Subject: PSEG Nuclear LLC's Response to Request for Additional Information for the Hope Creek Generating Station's Overall Integrated Plan in Response to March 12, 2012 Commission Order Modifying Licenses with Regard to Requirements for Reliable Spent Fuel Pool Instrumentation (Order Number EA-12-051)

**Response to Request for Additional Information
Overall Integrated Plan in Response to
Order EA-12-051 “Reliable Spent Fuel Pool Instrumentation”**

**Hope Creek Generating Station
Response to Request for Additional Information
Reliable Spent Fuel Pool Instrumentation**

Hope Creek Spent Fuel Pool Levels Elevation View

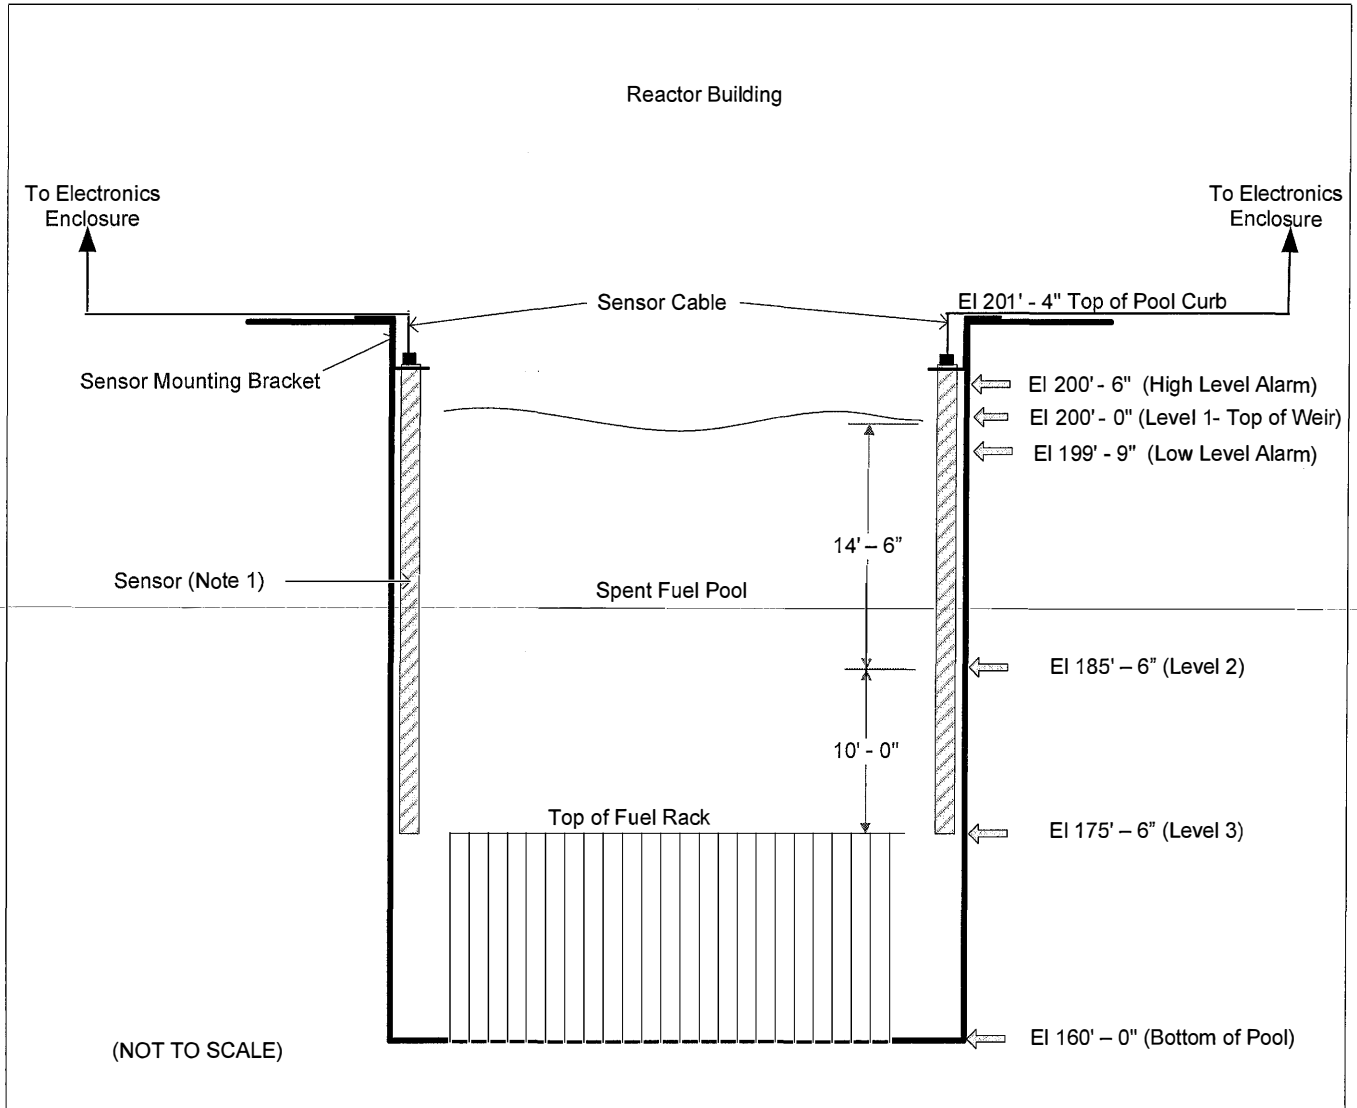
Please provide a clearly labeled sketch depicting the elevation view of the proposed typical mounting arrangement for the portions of the instrument channel consisting of permanent measurement channel equipment (e.g., fixed level sensors and/or stilling wells, and mounting brackets). Indicate on this sketch the datum values representing Level 1, Level 2, and Level 3, as well as the top of the fuel rack. Indicate on this sketch the portion of the level sensor measurement range that is sensitive to measurement of the fuel pool level, with respect to the Level 1, Level 2, and Level 3 datum points.

The sketch below provides an elevation view of the SFP for HCGS showing the Level 1, 2, and 3 datum points, elevation of the fuel racks, and other elevations related to the SFP and cooling system. It is anticipated that the final mounting arrangement (e.g., fixed level sensors and mounting brackets) will be available upon completion of the final design. The final design is scheduled for completion by the end of the second quarter of 2014. Details will be provided to the NRC in the August 2014, six-month OIP update.

(Note 1) – The sensor’s total span (i.e., measurement range that is sensitive to measurement of the fuel pool level) is approximately 25’ – 0”. The sensor is capable of continuously monitoring level over the entire range from the existing Hi Level Alarm down to the proposed Level 3. Actual length of the sensor will be determined during detailed design.

RAI-2
 HOPE CREEK SPENT FUEL POOL LEVEL SKETCH
 PLAN VIEW

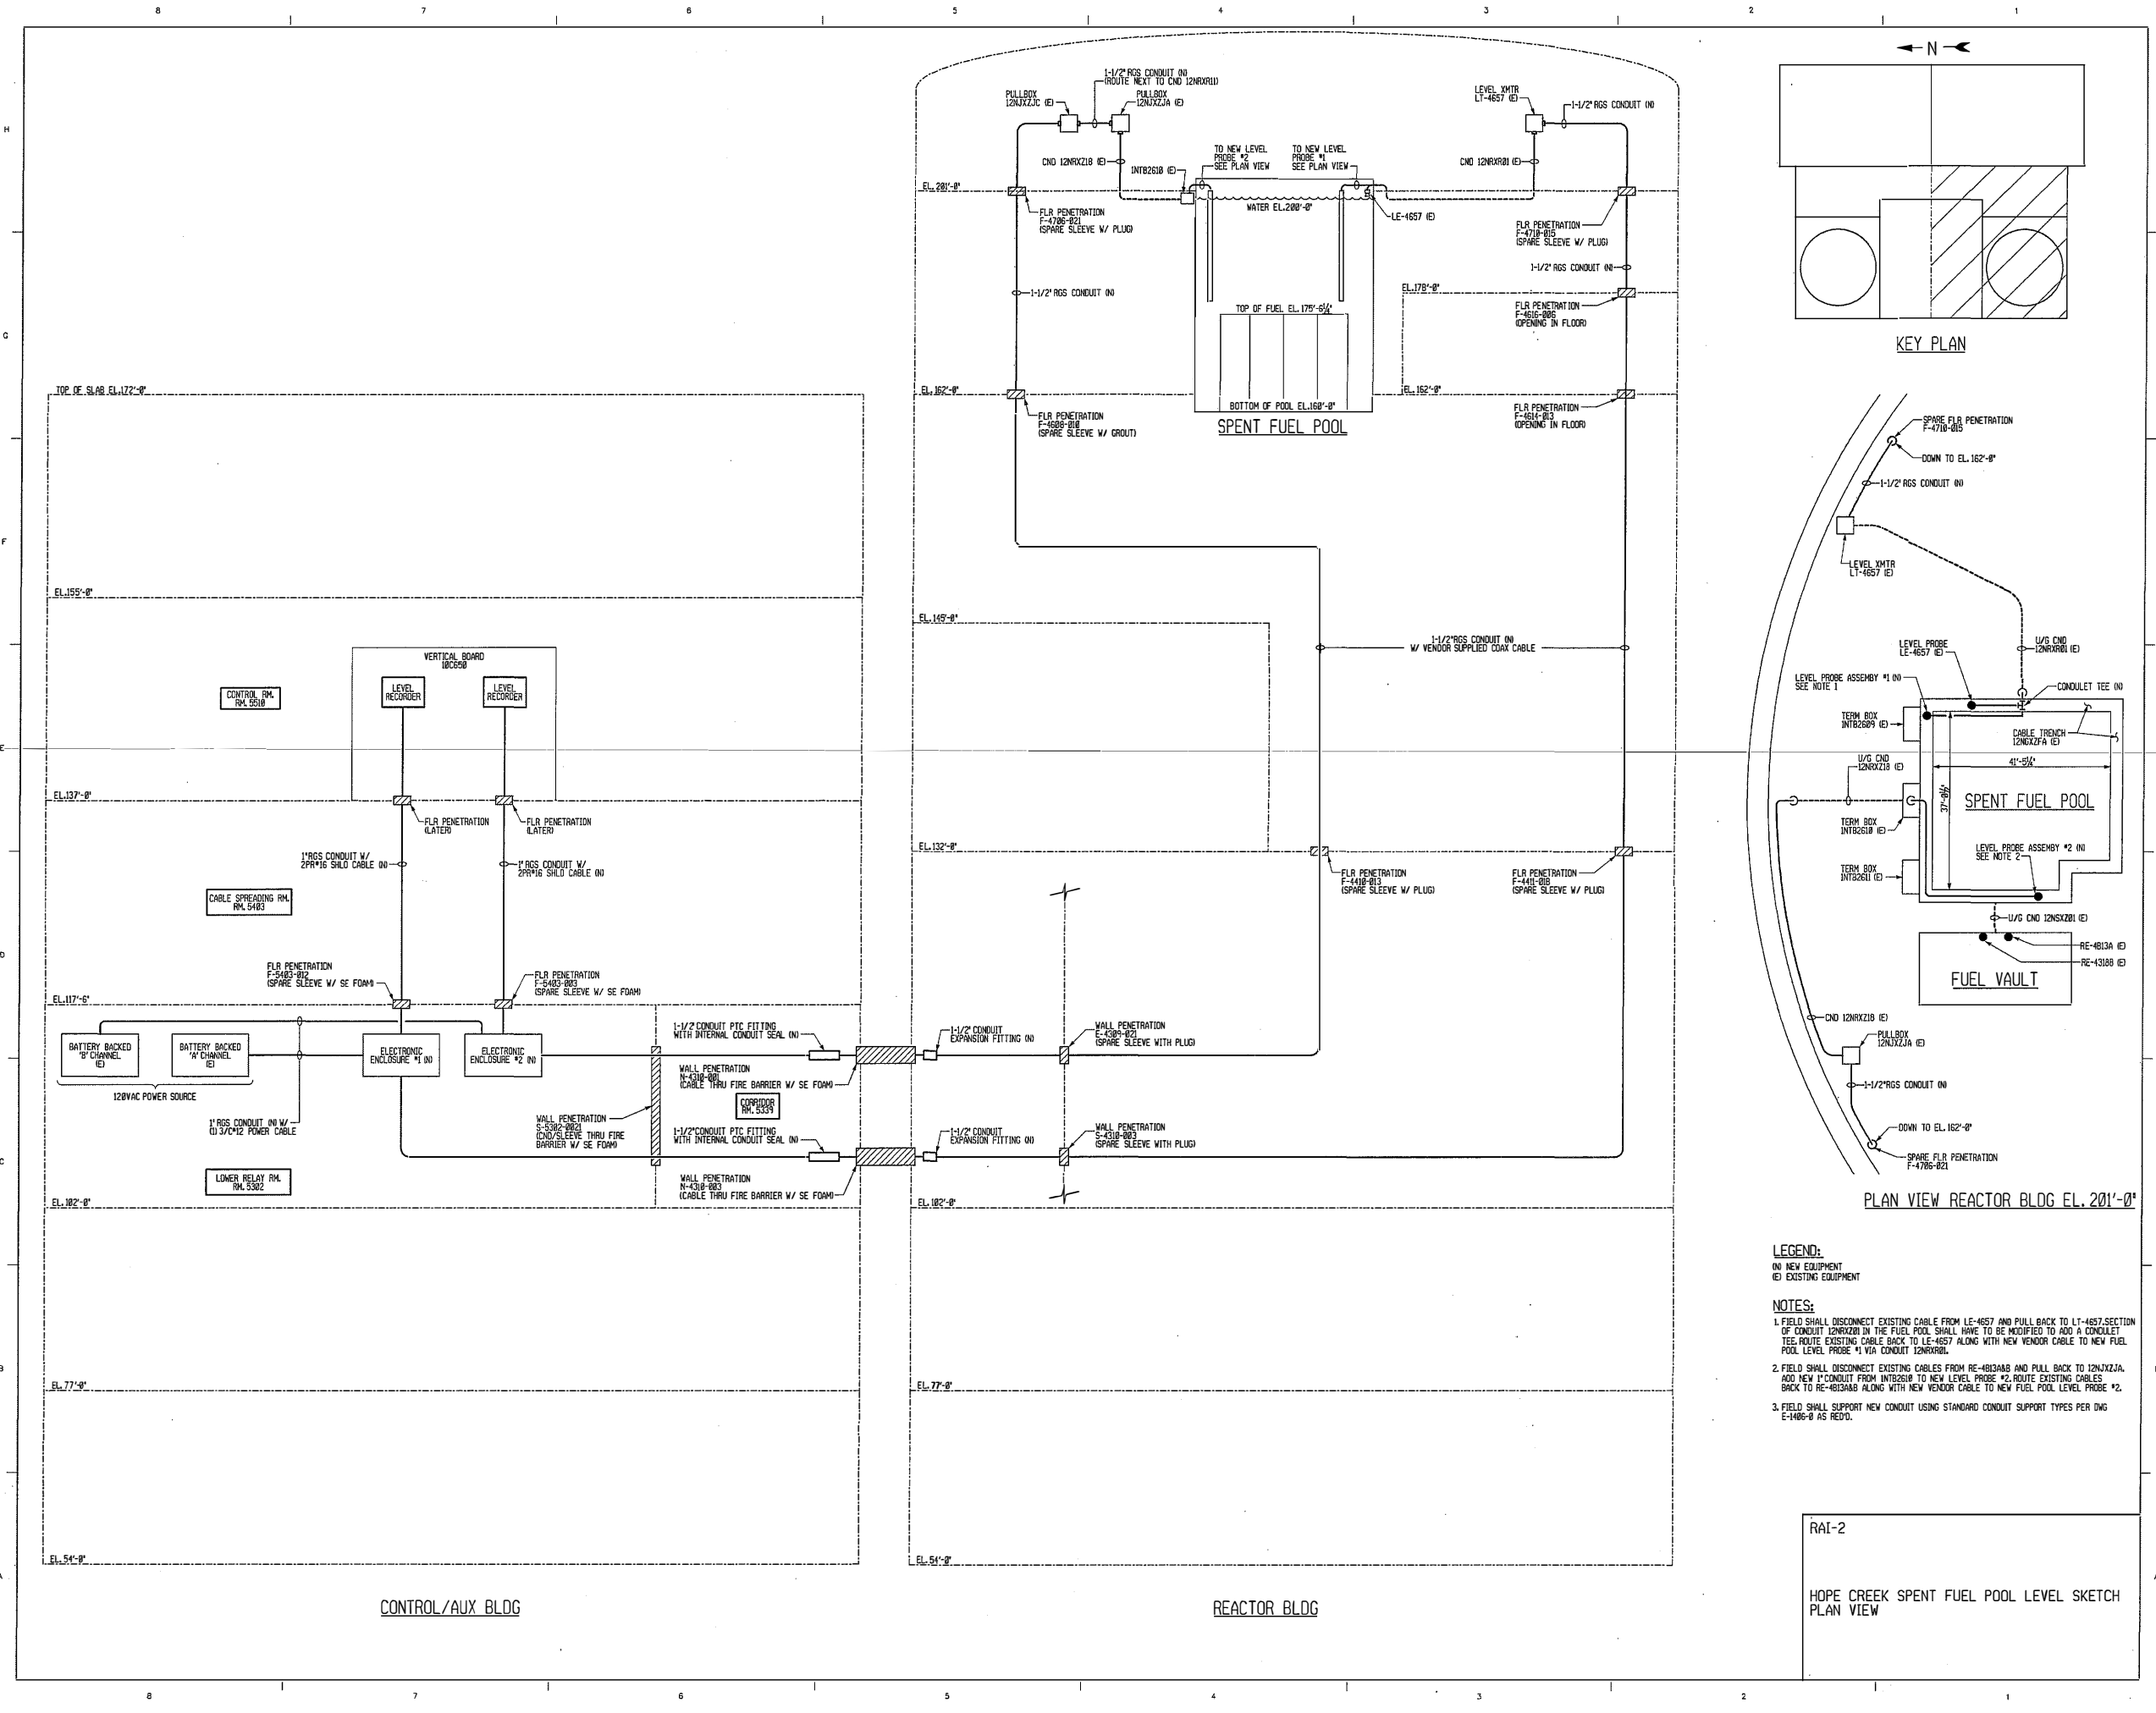
Please provide a clearly labeled sketch or marked-up plant drawing of the plan view of the SFP area, depicting the SFP inside dimensions, the planned locations/placement of the primary and back-up SFP level sensor and mounting brackets, and the proposed routing of the cables that will extend from the sensors toward the location of the read-out/display device.

The attached Hope Creek Spent Fuel Pool Level Sketch Plan View depicts the approximate locations for both the primary and back-up level sensors. As stated in the OIP for HCGS, both the primary and backup channels will be physically separated in accordance with the guidelines provided in NEI 12-02 Revision 1. Specifically, the sensors will be in different corners of the SFP and separated by a distance comparable to the shortest side of the pool. The interconnecting cables that extend from the sensors toward the location of the electronics enclosures will be installed using separate routes and separate but existing embedded conduits for transition from the SFP to the first junction point. The existing embedded conduits in the floor concrete provide a physical barrier to protect from potential missile hazards. From the first junction point until the cable leaves the Reactor Building, and transitions into the Auxiliary

Building, separate conduit routes are used to protect the cable from potential missile hazards. In the Auxiliary Building, the cables will be routed using HCGS installation criteria for cable separation E-1408 "Wire Cable Notes and Details" (Reference 9) over the entire length of the cable.
